Re: Single-Family Residence Renovations
10 Easy Street

In response to feedback provided by Greg Keyser following your regularly scheduled June 2, 2022 meeting, we are submitting the following revised application documents.

WEPLER HOLMONT RESIDENCE
10 EASY STREET,
ELLICOTTVILLE, NY 14731

06/24/22 ZONING APPLICATION

SITE PLAN - PROPOSED CONDITIONS

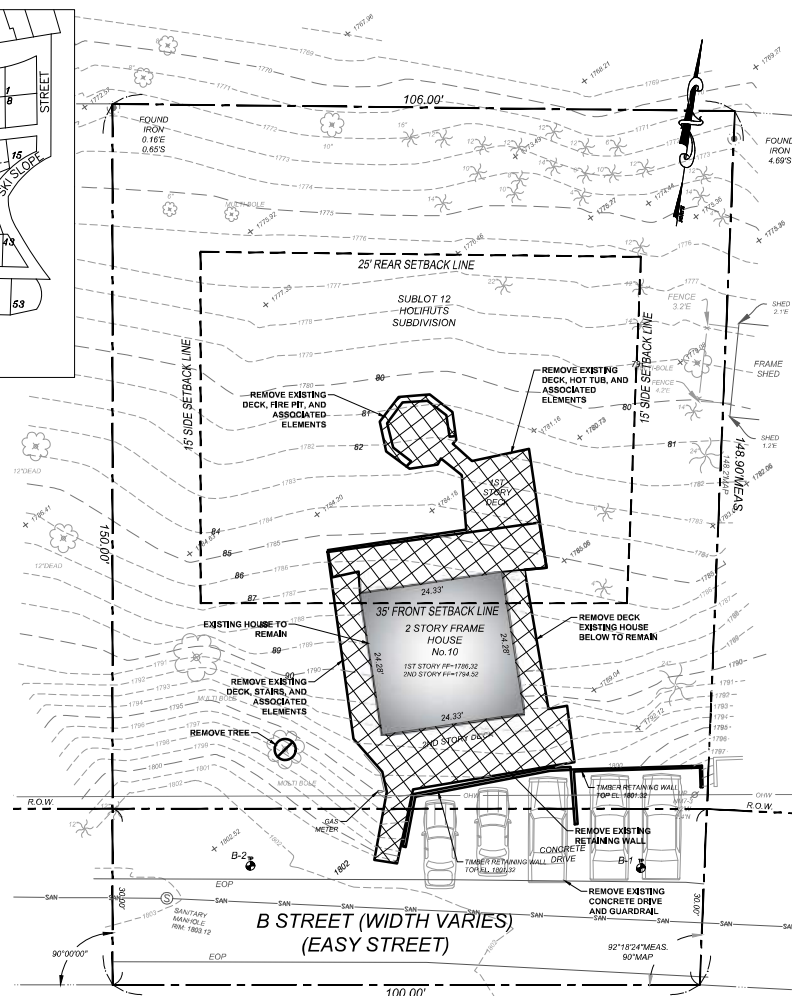
Site Plan, Sheet C1.01

Remove site plan sheets 1&2, dated 5/12/2022 (MDA Engineers title block) and replace with civil sheets C1.01 & C5.01 (Peninsula Architects title block) dated 06/24/22

- Additional dimensions showing setbacks to proposed retaining walls
- Vehicle outlines for existing parking area to clarify improvements in parking
- Stairs to grade near northwest corner of house
